Product Change Notice

PCN#: EE-PCN26033
September 4, 2026

DESCRIPTION OF CHANGE:
The Fuse SR-5H series has added UL certification an interrupting rating (IR) IR100A at 138Vdc.

BEFORE	AFTER
Body marking 6.3A		
Label 6.3A		
Label <6.3A

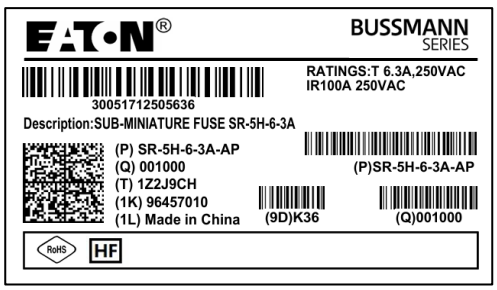
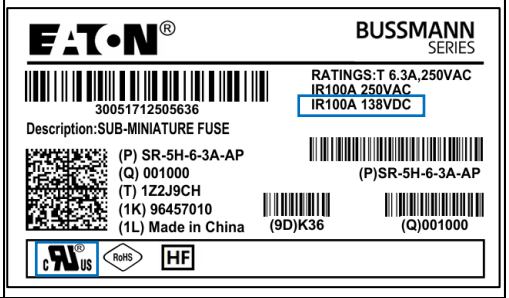
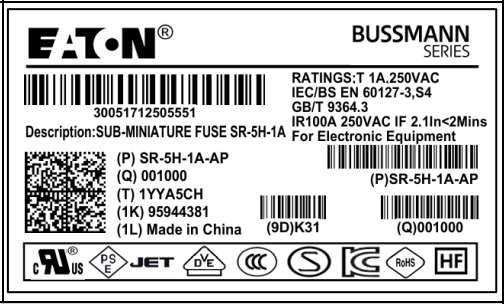
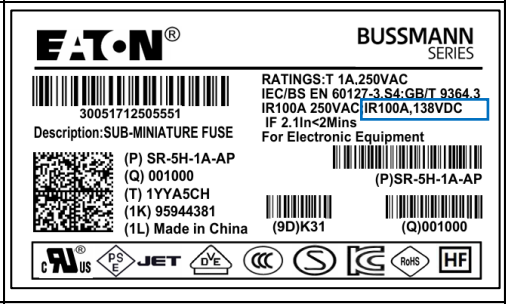
REASON FOR CHANGE:
The SR-5H Fuse series is now certified for DC voltage. The interrupting rating of 100A @ 138Vdc is now under certification. Product marking and packaging labels have been updated accordingly, as shown below.
